# MIL "ON" DTC P1235

YEAR(S)	MODEL(S)	ADDITIONAL INFORMATION
2013	FR-S

Some 2013 model year Scion FR-S vehicles may exhibit a MIL "ON" condition with Diagnostic Trouble Code (DTC) P1235 (High Pressure Fuel Pump Circuit). The Engine Control Module/ECM (SAE term: Powertrain Control Module/PCM) logic has been revised to address this condition. Use the following repair procedure for ECM (PCM) reprogramming.

Figure 1. Location of Authorized Modifications Label on 2013 FR-S

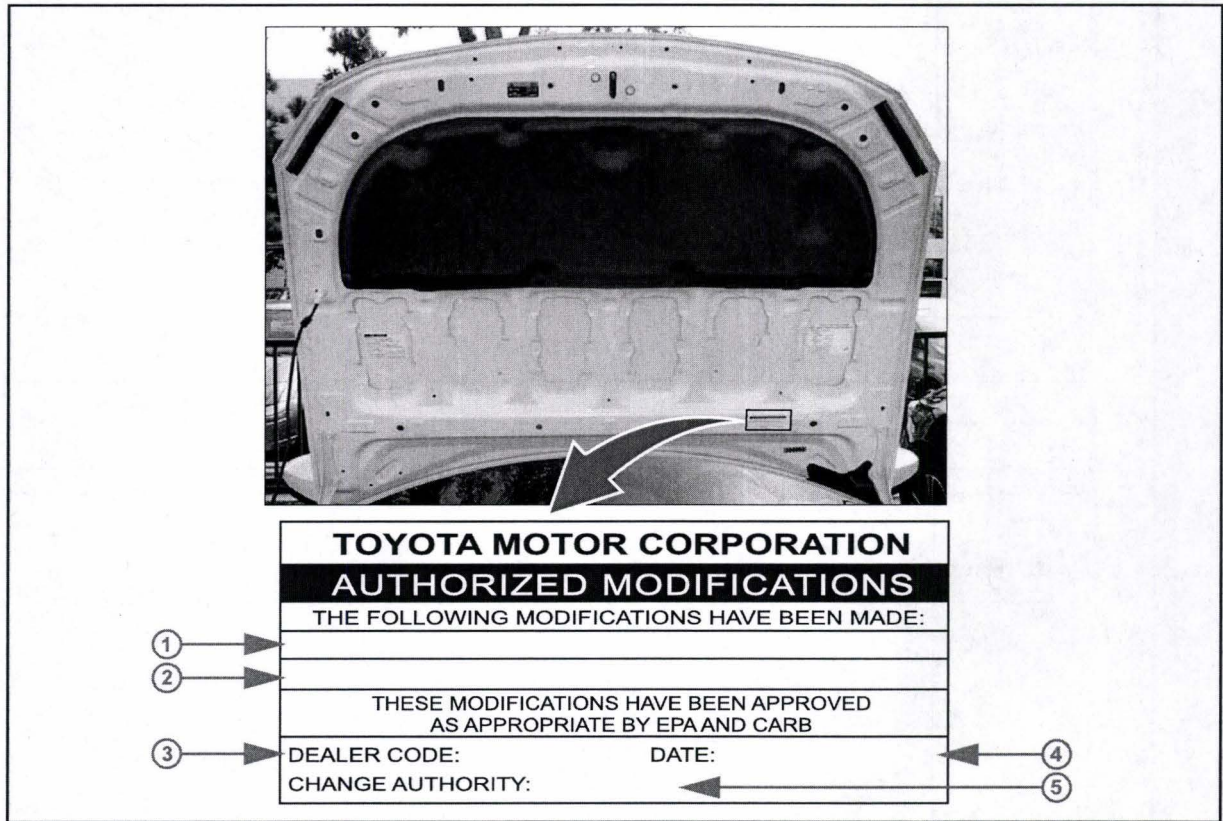
1. Confirm DTC P1235 is set.
2. Check for the Authorized Modifications Label affixed to the vehicle in the location shown in Figure 1. Confirm if the ECM (PCM) calibration has been updated. If the calibration ID listed is NOT the latest ECM (PCM) calibration — go to step 3.

4. Install the Authorized Modifications Label.
  - A. Using a permanent marker, enter the following information on the label:
    - ECM part number [Refer to the **Parts Information** section for the **CURRENT PART NUMBER**]
    - Calibration ID(s) [Refer to the **Calibration Identification Chart** for the **NEW CALIBRATION ID**]
    - Dealer Code
    - Repair Date
    - Change Authority [**This bulletin number**]
  - B. Affix the Authorized Modifications Label to the vehicle at the location shown in Figure 1. The Authorized Modifications Label is available through the MDC, P/N 00451-00001-LBL.
5. Start the engine and warm it up to normal operating temperature and test drive to confirm proper vehicle operation.

1	Replacement ECM (PCM) Part Number (i.e., SU003-04567)
2	New Calibration ID(s) (i.e., ZA1JA00D)
3	Dealer Code

4	Date Completed
5	This SB Number
